**TOWN OF MOUNTAIN VILLAGE  
REGULAR DESIGN REVIEW BOARD MEETING  
THURSDAY SEPTEMBER 5, 2019 10:00 AM  
2nd FLOOR CONFERENCE ROOM, MOUNTAIN VILLAGE TOWN HALL  
455 MOUNTAIN VILLAGE BLVD, MOUNTAIN VILLAGE, COLORADO  
AGENDA**

**TO:** Design Review Board  
**FROM:** Sam Starr, Planner  
**FOR:** Meeting of September 5, 2019  
**DATE:** August 27, 2019  
**RE:** Initial Architectural and Site Review for a new single-family home on Lot BC105, 114 Lawson Overlook

<b>JACK WESSON ARCHITECTS INC.</b> 110 SOUTH PINE STREET TELLURIDE, COLORADO 81435 TEL: 970.728.9755 FAX: 970.728.9724 jwesson@me.com www.jackwessonarchitects.com
PROJECT NAME: BC 105 MOUNTAIN VILLAGE, COLORADO 81435	SHEET DESCRIPTION: COVER SHEET
7-29-19 DRB PACKAGE 4-29-19 REVIT 3D	SHEET NUMBER: A-000

SHEET NUMBER: A104

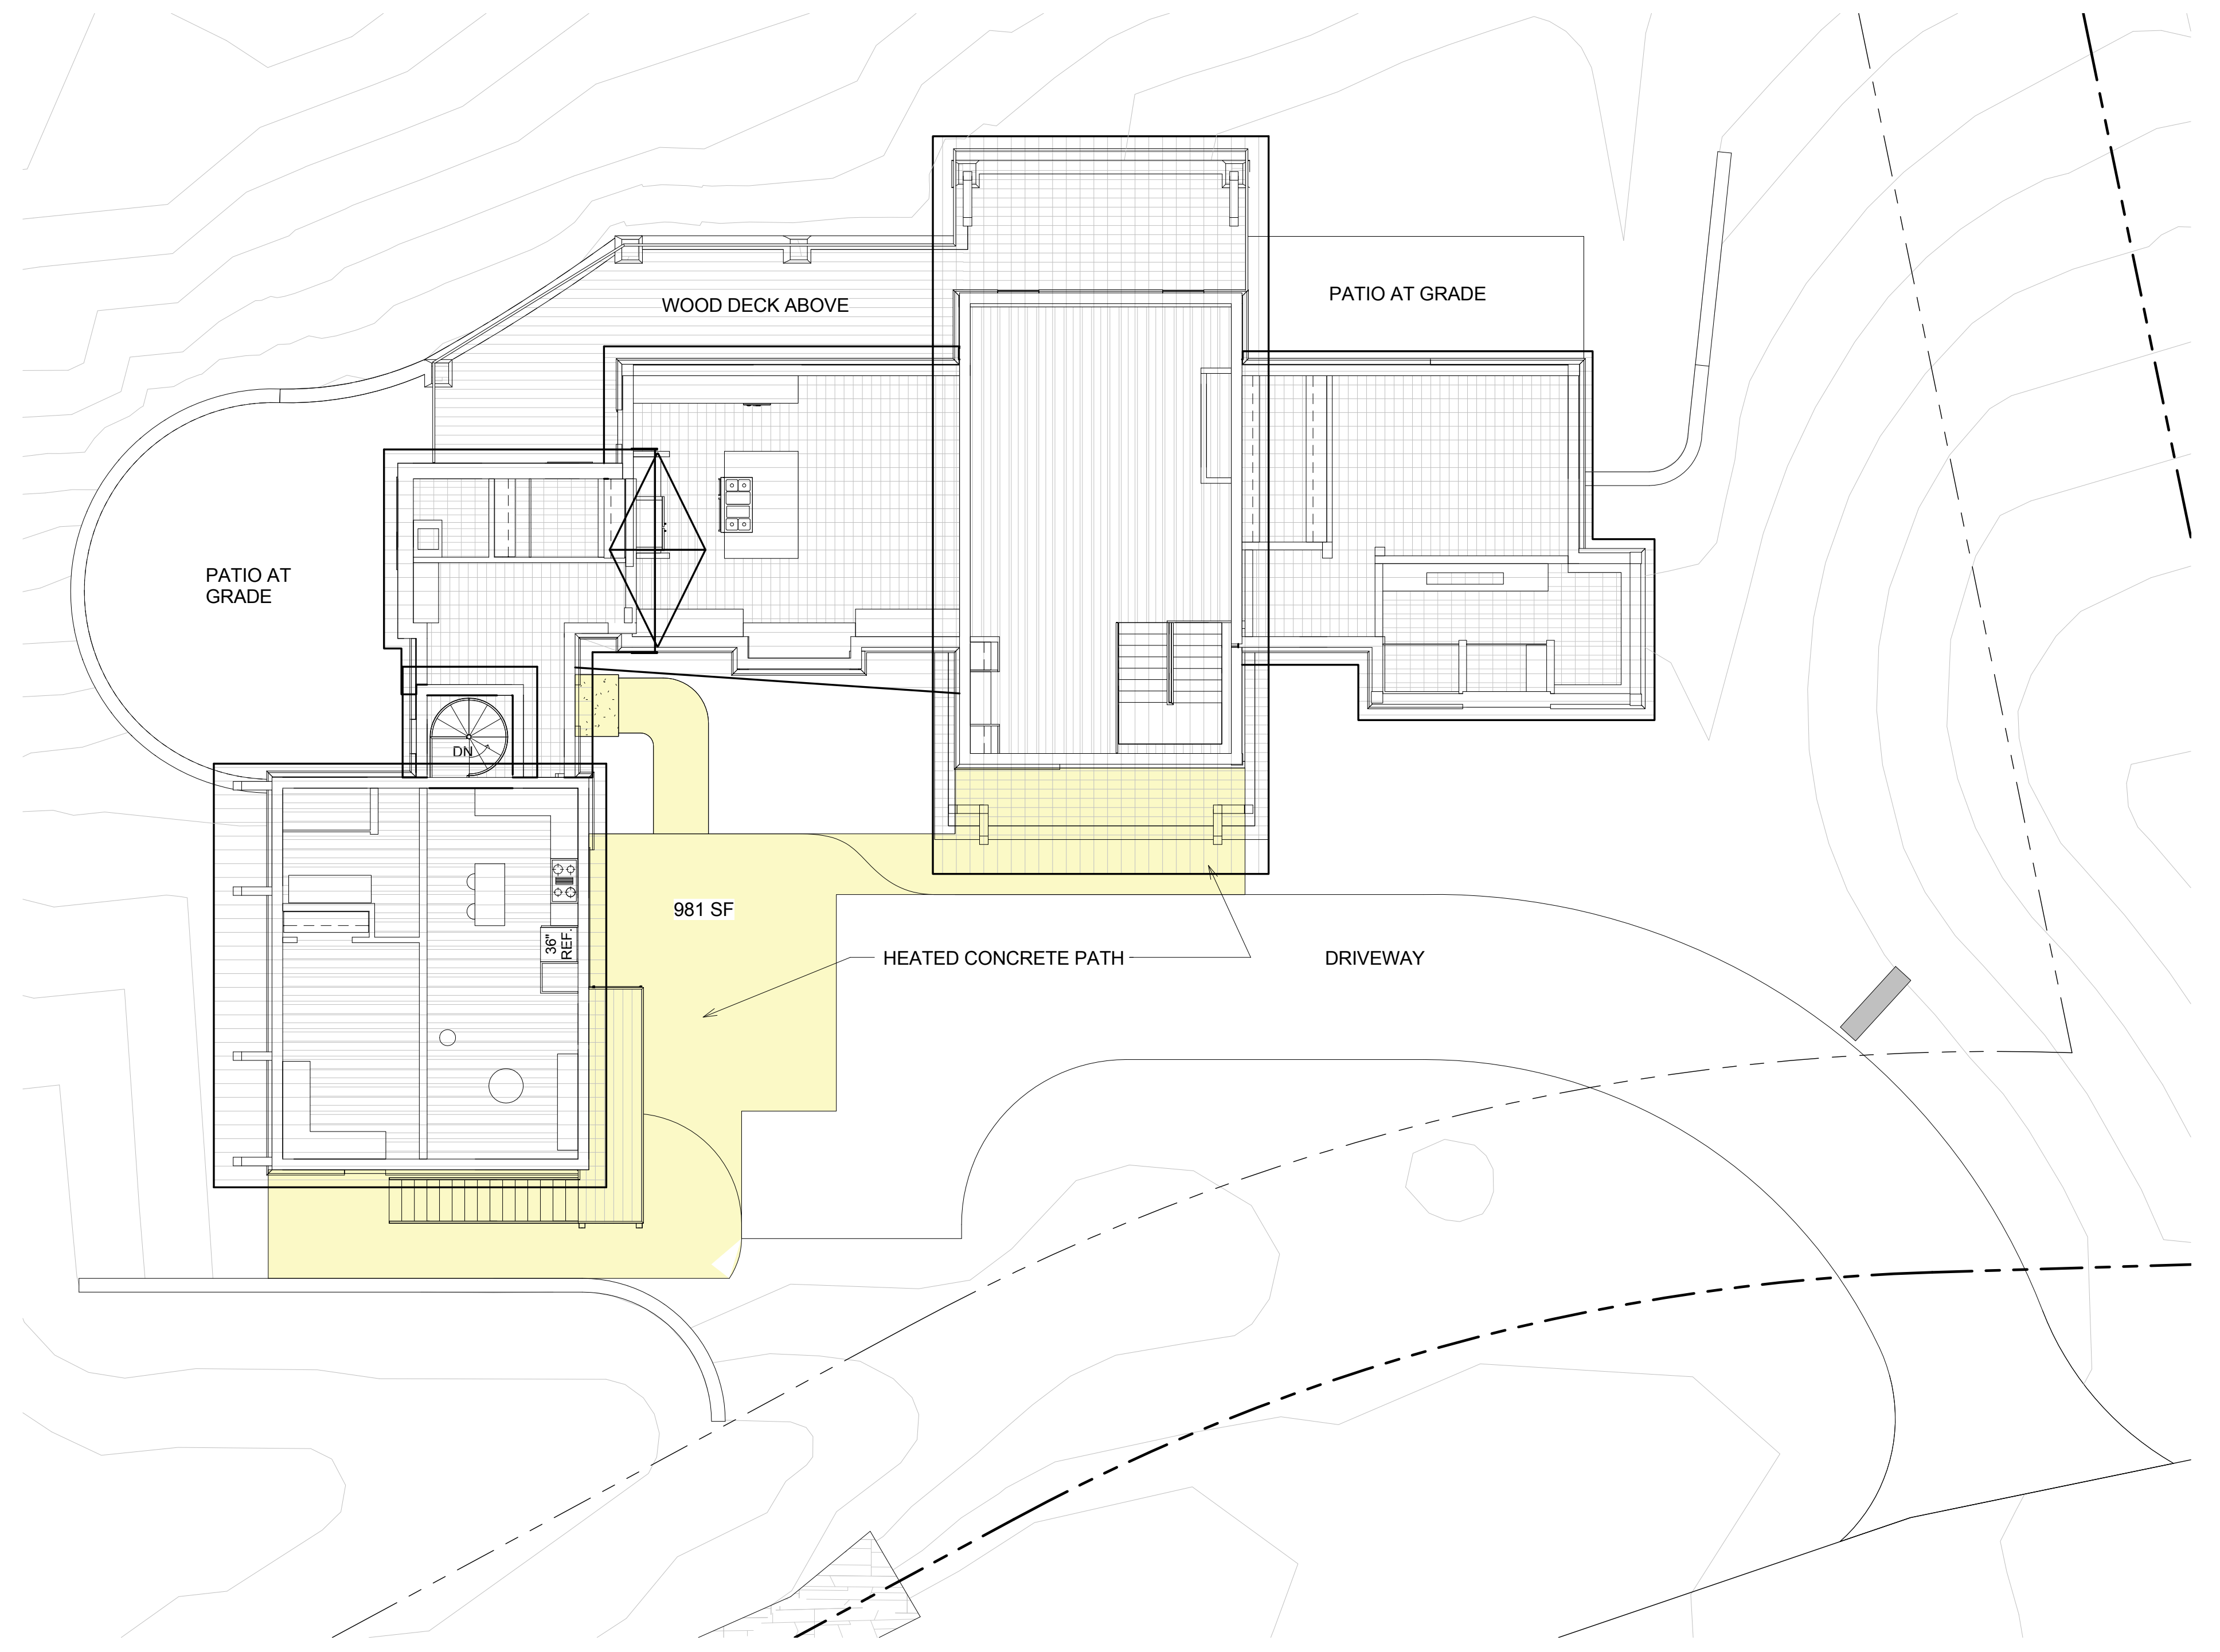
LED strip lighting. To comply with the updated lighting regulations, staff recommends that the applicant prepare an exterior lighting plan to be submitted prior to final review. The information provided with the lighting plan should include (but not be limited to): foot-candles, max delivered lumens for the bulbs used, max temperature, and proposed dimmer/management systems. This plan would need to be prepared by a certified lighting designer.

6. *Applicant shall submit an exterior lighting plan prepared by a licensed professional that includes bulb information, an isometric footcandle diagram, and dimmer/lighting management system information.*
7. *Applicant shall provide an address identification sign plan prior to Final Review.*
8. *Applicant shall revise the construction mitigation plan prior to Final Review to include construction fencing around the entirety of the site and outside of the General Easement except for areas that are already devoid of vegetation and otherwise disturbed such as the proposed driveway area.*

SHEET NUMBER: **A300**

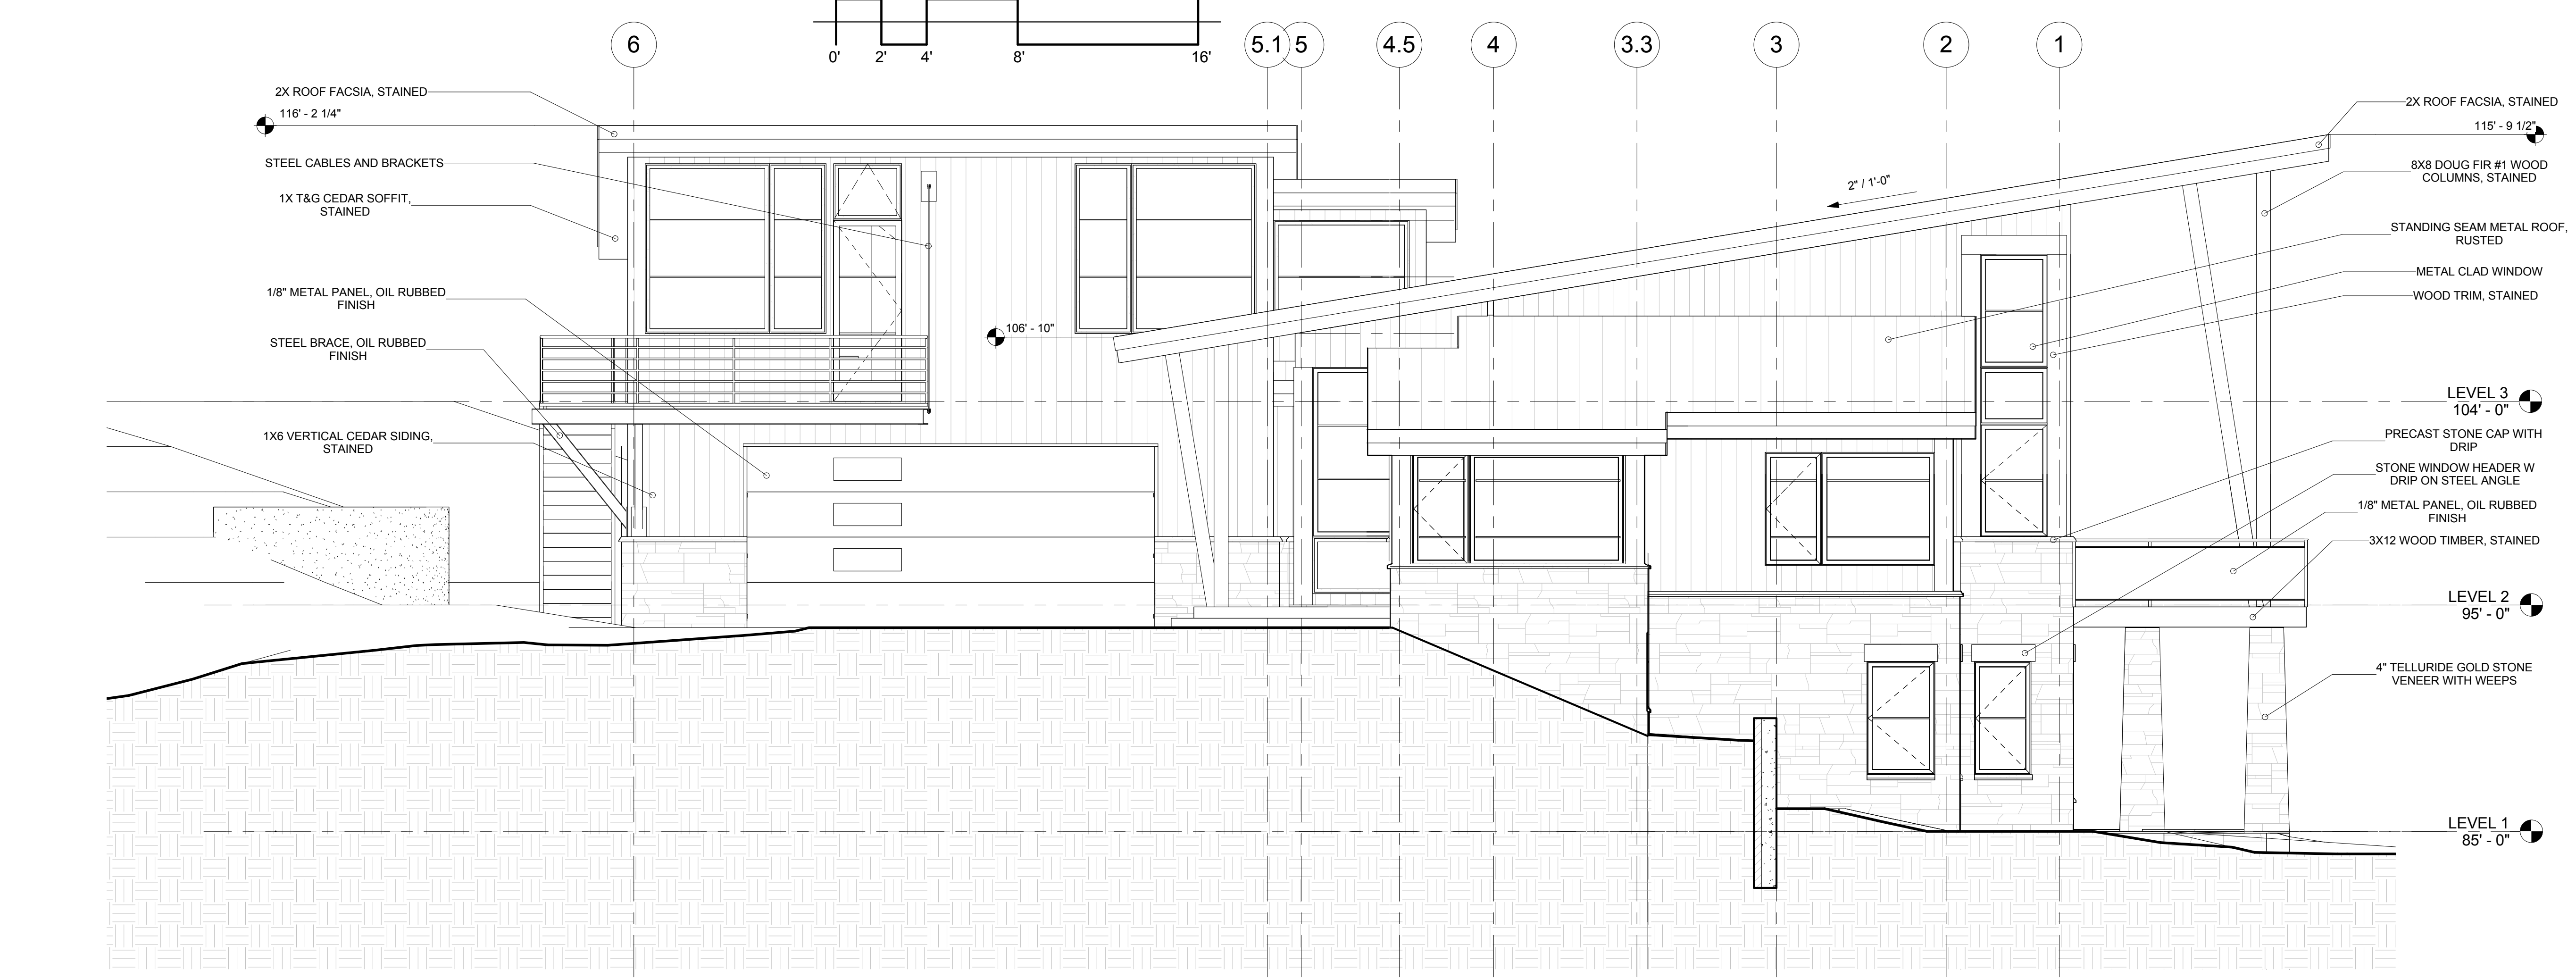
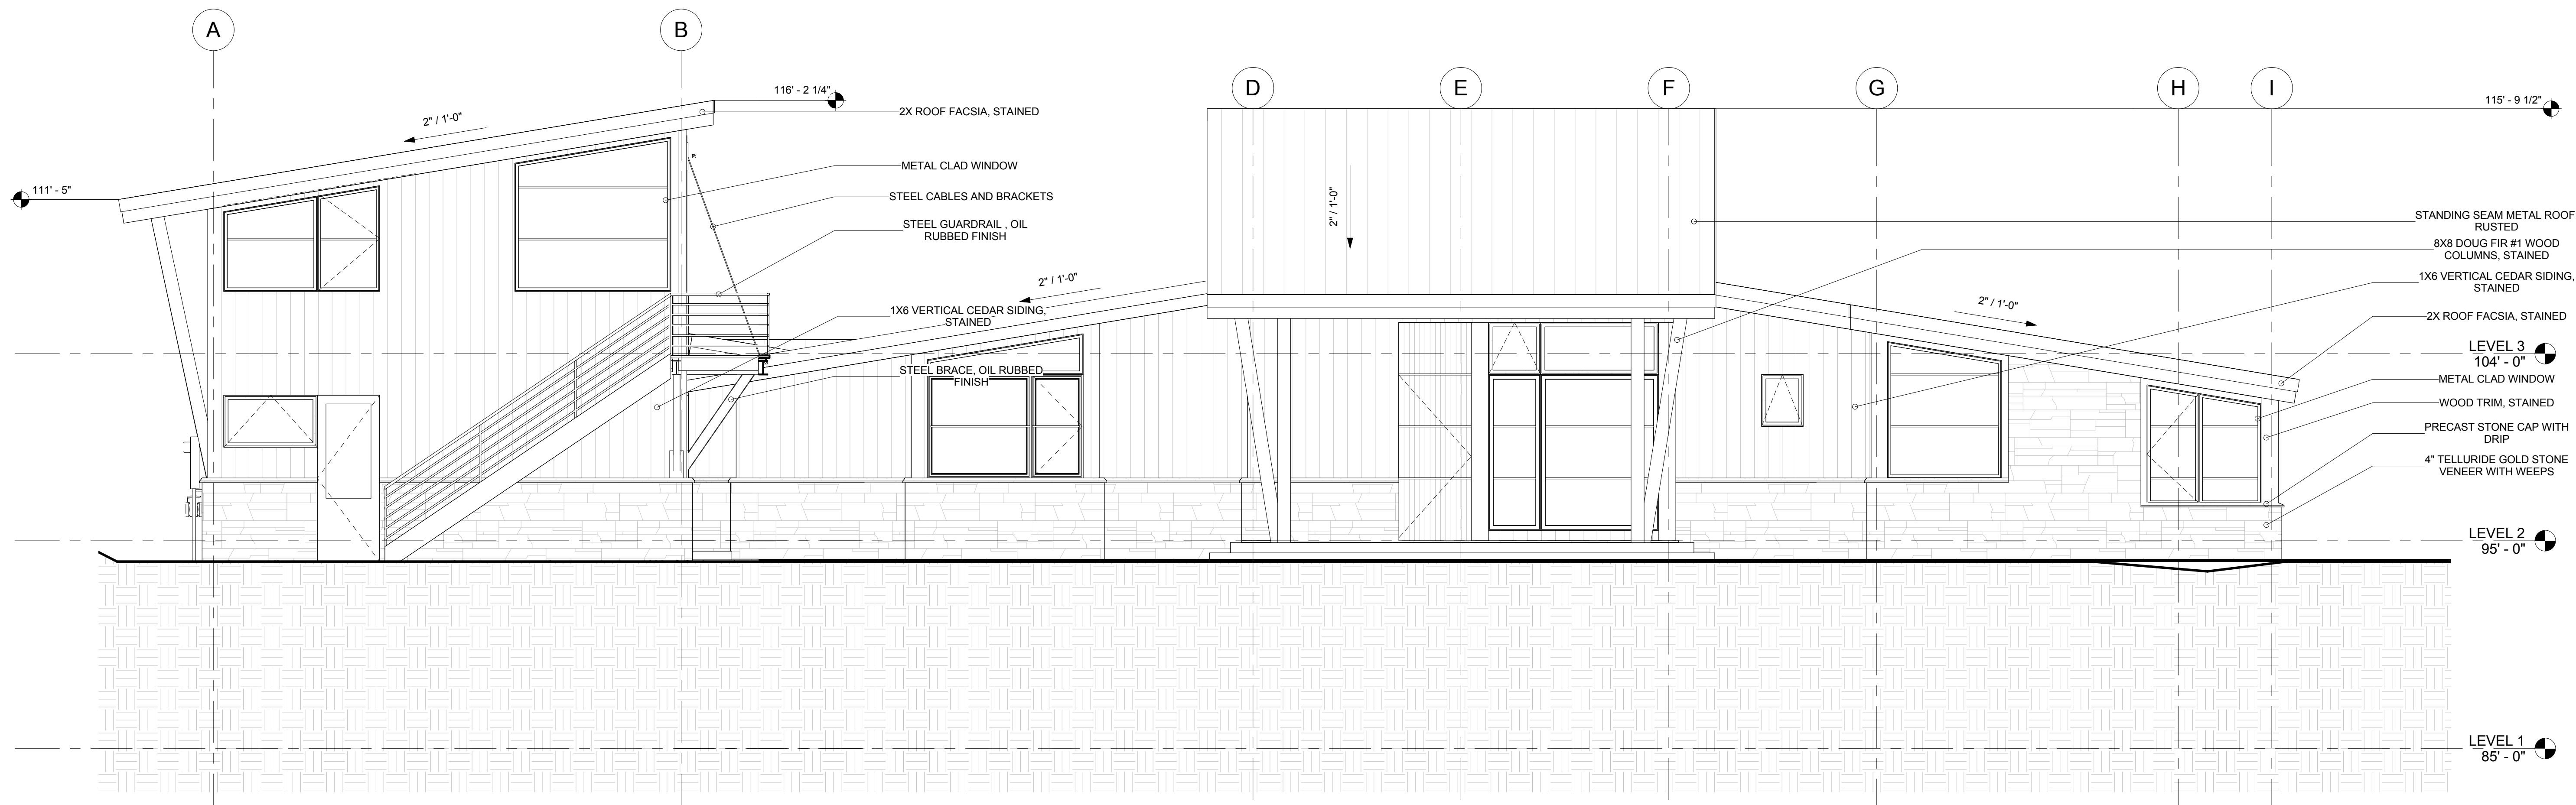
The average height for the proposed design is code compliant at 22 feet 8 inches. The proposed maximum height is 35 feet, which is the maximum height allowed for a single-family home. To verify that the finished product matches the proposed plans, staff recommends that a monumented land survey shall be prepared by a Colorado public land surveyor to establish the maximum building height and the maximum average building height. This condition shall be carried over to any Final Review approval as it is a construction condition.
